STAFF REPORT

DATE: 05/13/19

ITEM #: 4A - Public Hearing

TO: Planning Commission
FROM: Ken Roberts, Planning Director
AGENDA ITEM: **Zoning Map Amendment and the Springs Apartments Preliminary Plat and Preliminary Planned Unit Development (PUD) Plans**
REVIEWED BY: Ben Prchal, City Planner
Jack Griffin, City Engineer

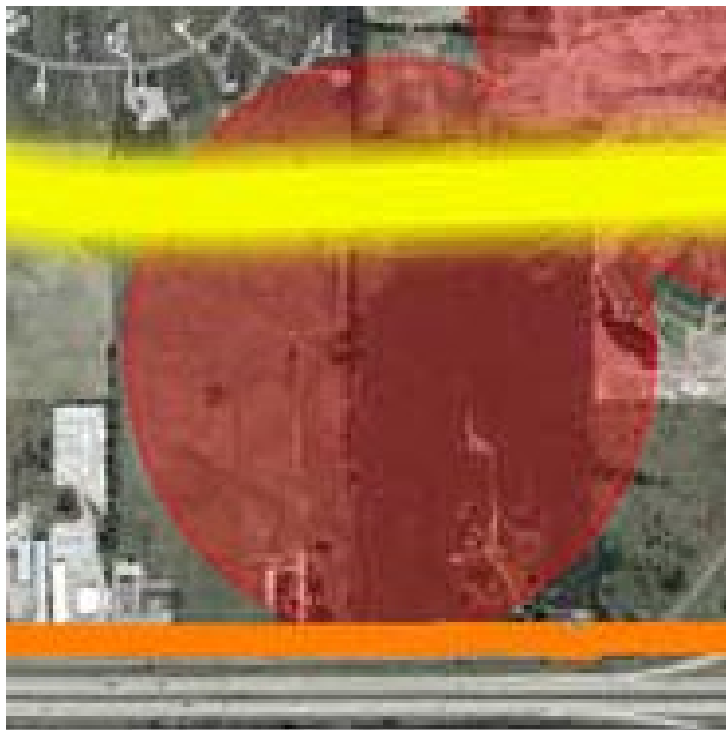
Garages. The proposed plans include 120 attached garages and 7 detached garage buildings with 6 garage stalls in each building. There also is a proposed maintenance garage building for the residents to perform minor service to their vehicles and to wash their vehicles.
